SECTION 00 91 13.01 - ADDENDUM #1

The following provisions replace, revise, and/or add to the drawings and specifications titled "Howell Community Park: Site Improvements" dated "June 21, 2016. The contractor shall acknowledge said provisions by recognizing receipt of this Addendum on page I of the Louisiana Uniform Public Work Bid Form.

HEAVY DUTY ASPHALTIC PAVEMENT

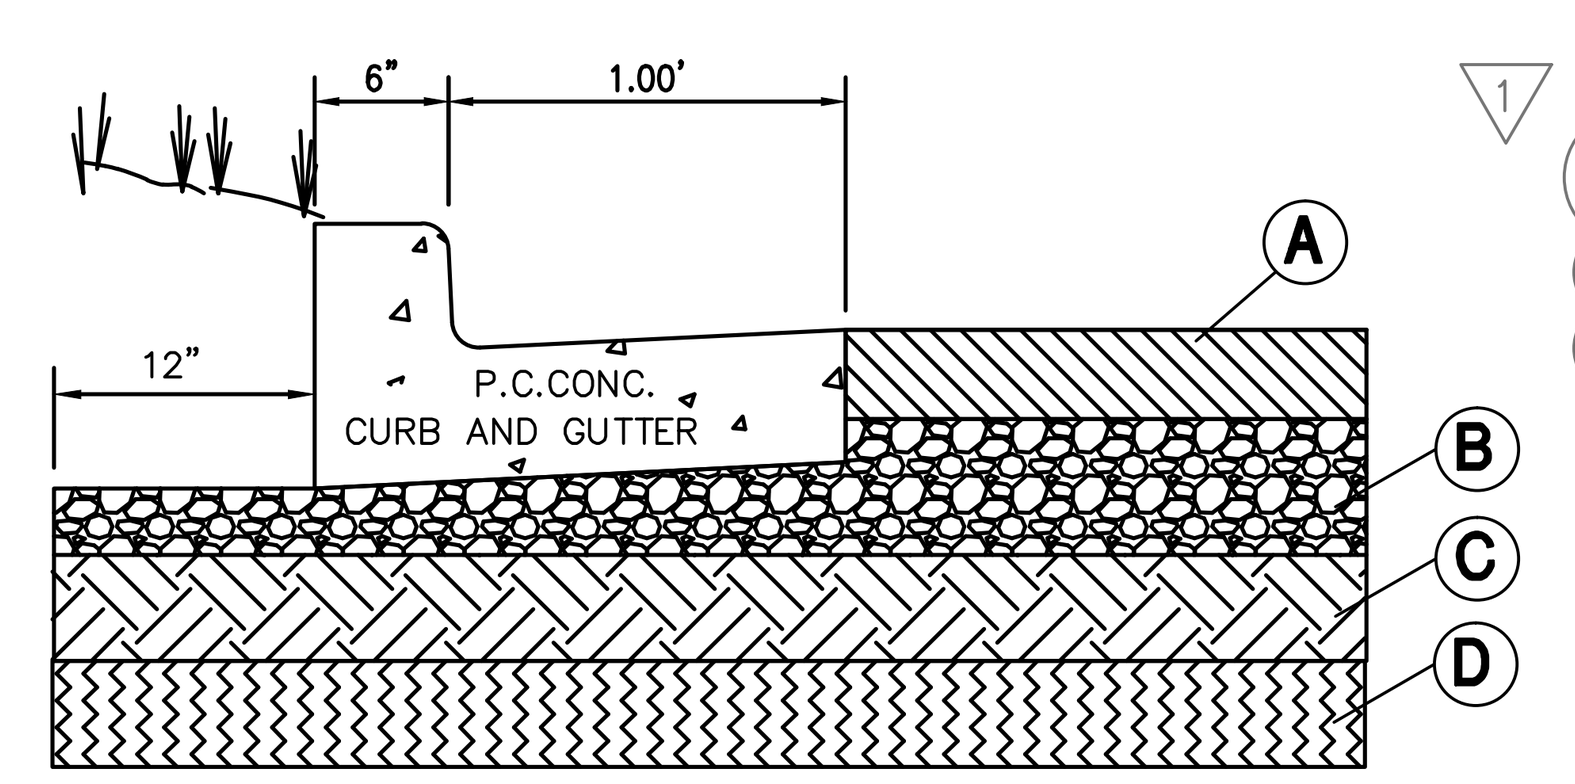
14. C-6 Detail Sheet
    a. Revised Heavy Duty Asphaltic Pavement section to consist of the following:
        i. Pavement Alt. 1: 3.5” asphaltic concrete wearing course over 8” class II granular base course over 12” compacted structural fill
        ii. Pavement Alt. 2: 3.5” asphaltic concrete wearing course over 4” class II granular base course over 10” soil-cement treated base

CURB CUT DETAIL

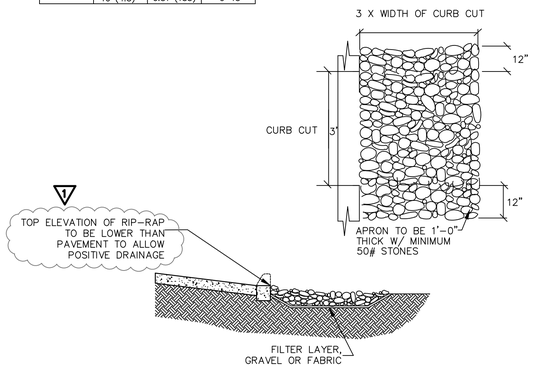
15. C-7 Detail Sheet
    a. Revised note on curb cut detail to specify that rip-rap shall be placed below pavement elevations.

DETAIL SHEET

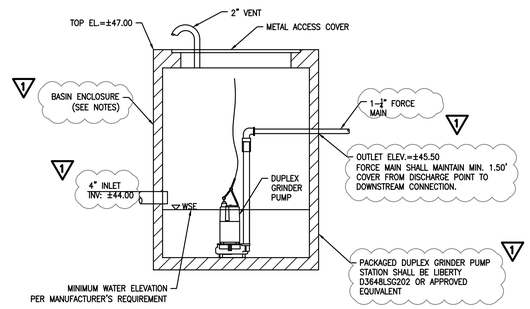
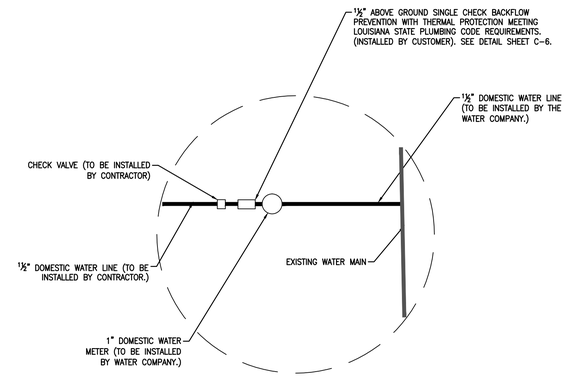
1. Regarding the sewer pump station:
    a. What is the diameter and depth of the basin?
    Refer to the revised sheet C-9. The minimum diameter is 36". The depth for the specified model is 48", but may vary, depending on the manufacturer.

b. What are the pump conditions (GPM @ TDH)?
    Refer to the revised sheet C-9. The pump shall be capable of pumping a minimum of 10gpm at 50ft TDH.
    c. What do you require as far as controls?
    Refer to the revised sheet C-9. The system shall include all level & pump controls in accordance with the manufacturer's recommendation to ensure proper operation.

17. C-9 Detail Sheet
    a. Revised outfall pipe note to allow for multiple material types.
    b. Revised pump station inlet elevation.
    c. Revised pump station outlet elevation & provided minimum cover.
    d. Revised force main diameter.
    e. Revised pump station model number.
    f. Added grinder pump notes.
    g. Relocated water service connection detail to this sheet.

DRAWN	AMR
CHECKED	JPL
ISSUED DATE	6/21/2016
ISSUED FOR	BID
PROJECT NO.	16-111
FILE	16-111 L-1 Landscape Plan FINAL
SHEET	L-3.5

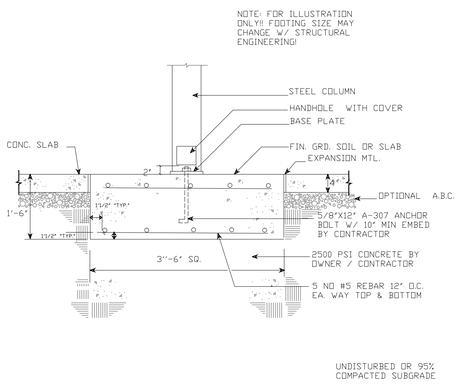
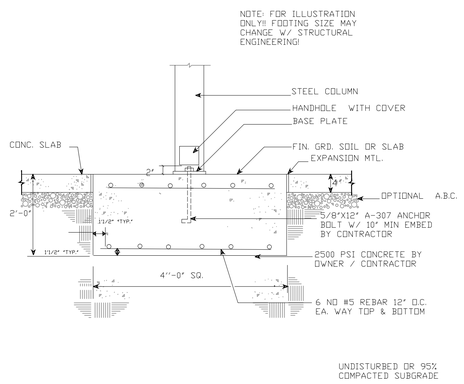
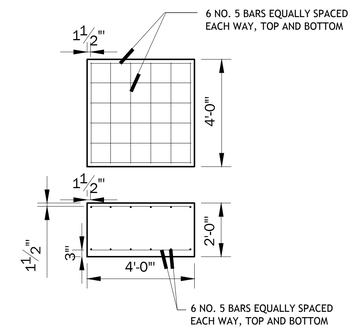
1. In the specifications Division 107300 under description of product it lists 2 pavilion sizes 24 x 34 and 16 x 24 but the plans and details show 16 x 33 and 16 x 18. Can you clarify which sizes are correct?
   There are two pavilion sizes listed in the plans 16x33 and 16x18.
   Please replace verbiage In Section 107300, 1.1, A.,
   with **"Pavilion Types: 1. ARC 16x33 (ARC ROOF) with MEGA METAL ROOF. 2. ARC 16x18 (ARC ROOF) with MEGA METAL ROOF"**
   and Section 107300, 1.1 B. Roof Slope **3/12**
   and Section 107300, 1.1 C. **"(MCH) is 8'-2 7/8" for 16x33 Pavilion and (MCH) is 8'-2 ½" for the 16'x18' Pavilion"**
